GE Hitachi Nuclear Energy

MFN 09-163

Subject: Response to Portion of NRC Request for Additional Information Letter No. 275, Related to ESBWR Design Certification Application - Auxiliary Systems - RAI Numbers 9.1-96 through 9.1-115

**Response to Portion of NRC Request for
Additional Information Letter No. 275
Related to ESBWR Design Certification Application
Auxiliary Systems
RAI Numbers 9.1-96 through 9.1-115**

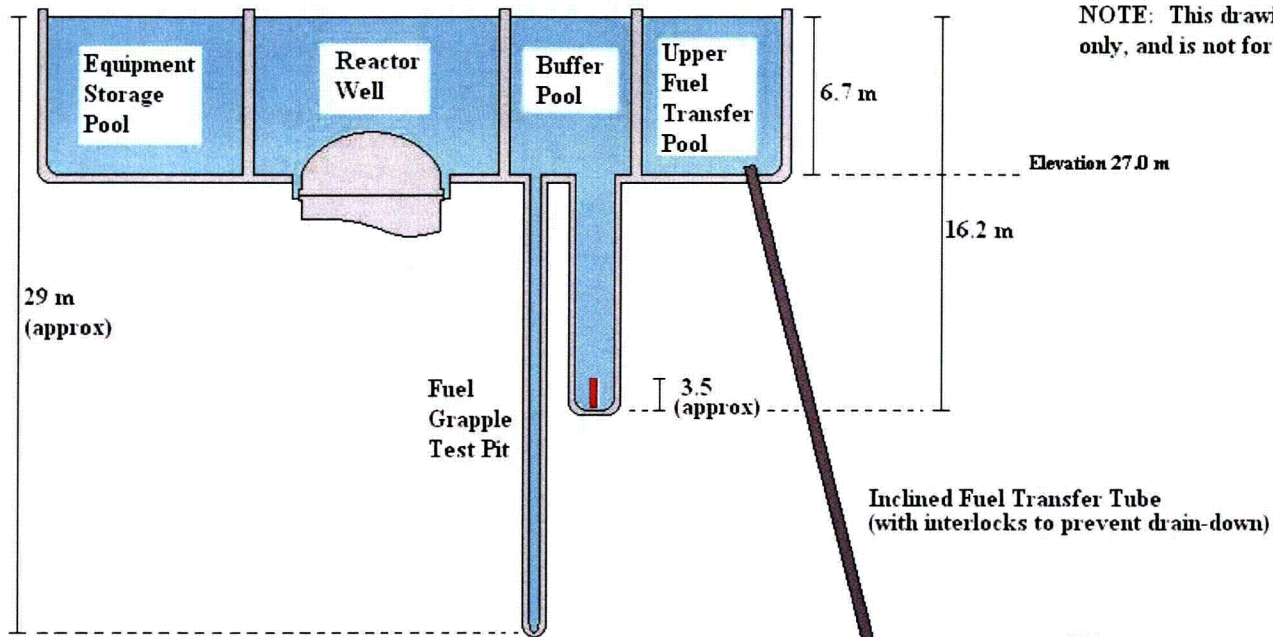
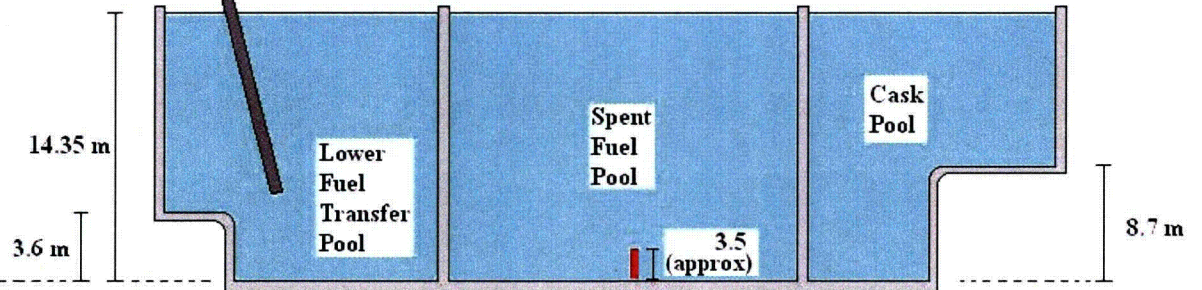
The staffs review of pools that could potentially contain new or spent fuel includes consideration of events that could lower the level of the pools and uncover fuel. Please provide an elevation diagram of the spent fuel storage pool, lower fuel transfer pool, and cask pool, including any pits in the pools and interfaces (e.g., gates or weirs) between/among the pools or pathways that could potentially lower the water level in the pools to unacceptable levels. Similarly, provide an elevation diagram of the buffer pool, reactor well, upper fuel transfer pool, inclined fuel transfer system, and equipment storage pool, as well as any interfaces or pits in the pools. Elevation diagrams should indicate the height of the top of fuel in any pool that could contain fuel.

For additional clarification, please review the sketch in Attachment 1 that shows, in very basic terms, the configuration of these pools.

The drawing is not done to scale and is only intended to show the depth of normal water level from the pool floors including shelves and pits.

Certain items such as gate dimensions have not been determined yet and are not included on the sketch. The quantity of weirs in each pool has not yet been determined. Weirs are located at or above normal water level and therefore cannot lower the level of the pools below normal water level.
